APPENDIX G

SECTION 4(F) *DE MINIMIS* COORDINATION

RE: STIP Project Number I-2513; I-26 Connector in Asheville, Buncombe County,
North Carolina, WBS No. 34165.1.2

RESPONSE TO AGENCY COMMENTS

Project Reference No.	J-25074
MINIMIZATION AND AVOIDANCE CARRIER PARK ADJACENT ANBOY ROAD

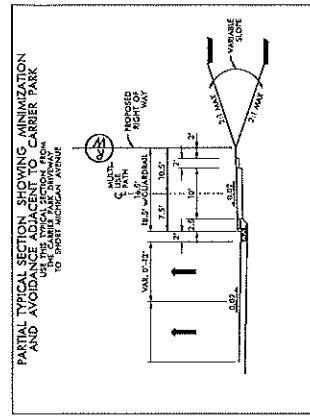
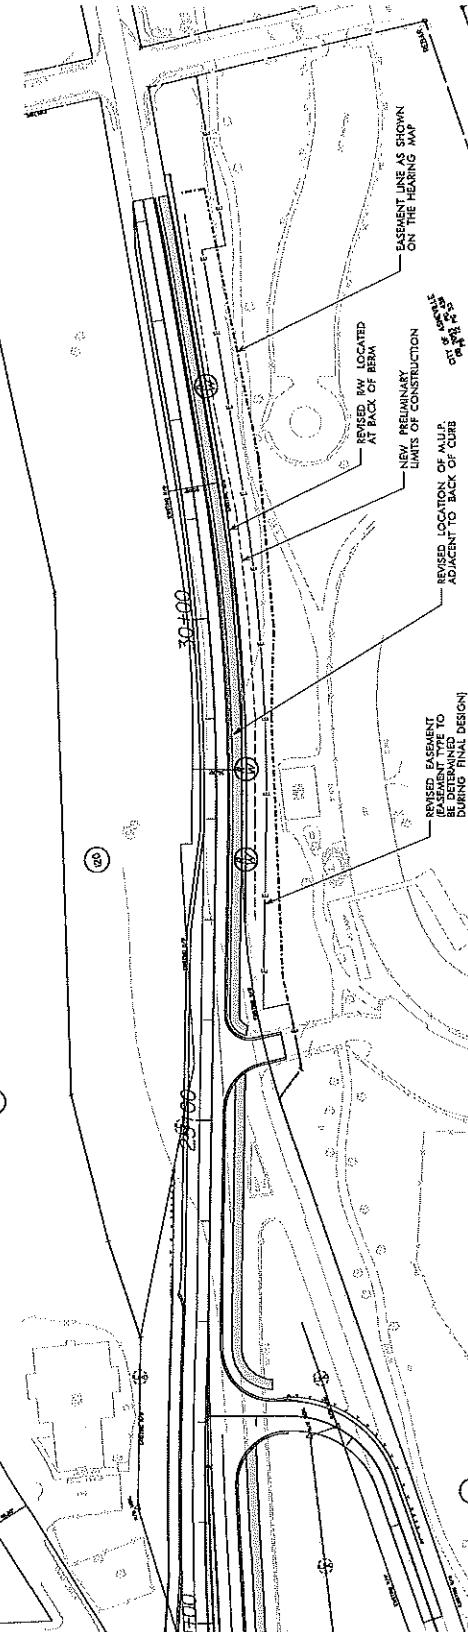
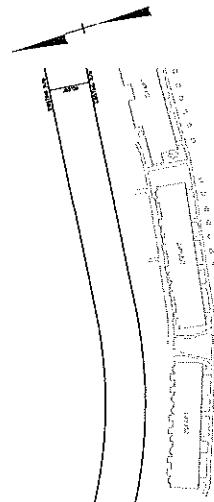
The City requested the project team provide a sketch showing a design option that avoids the walking trail that they can review before signing the concurrence letter noting FHWA's determination of Section 4(f) *de minimis*. The City noted they could provide the project team a plan view showing the limits of the grant-funded land for use in preparing the design sketch.

- The project team to provide a sketch to the City of Asheville showing a design option that avoids the walking trail.
- City to provide the project team a plan view showing the limits of the grant-funded land for use in preparing the design sketch.
